McLaren Artura Body Harness Rework

Bulletin type:	Service Campaign
Reference number:	N/A
Campaign reference:	SCB 16 M 001
Attention:	Retailer Aftersales Managers, Retailer Service Managers, Retailer Service Advisors, Retailer Technicians
Affected vehicles:	McLaren Artura
Situation:	Addition of spacer bushes and felt tape to the body harness and carbon tub
Procedure:	Action affected vehicles prior to handover. Please refer to the information outlined in this document to complete the required work
Date:	07 October 2022

Figure 1: Location of rework area

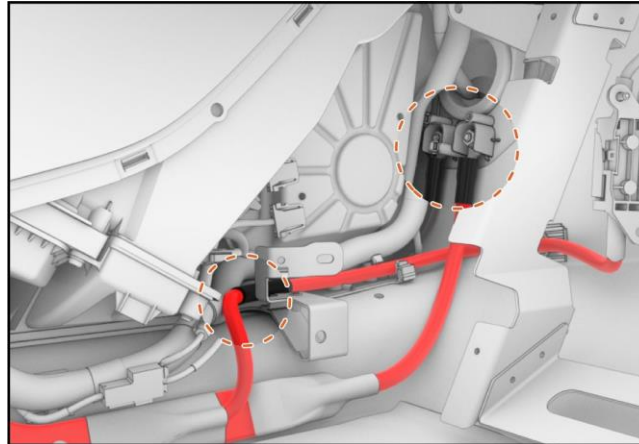
Through continuous product quality monitoring, McLaren Automotive has identified that on certain McLaren Artura vehicles that a body harness enhancement is required in the area behind the HVAC shroud of the tunnel console.

To carry out the required rework, two split spacer bushes are required to be fitted around a specific cable of the body harness and a felt tape applied to the carbon tub. Document SCB 16 M 001 WI (attached with this bulletin), contains the relevant work instructions and care points to ensure the work is carried out to bring the vehicle up to the current manufacturing standard.
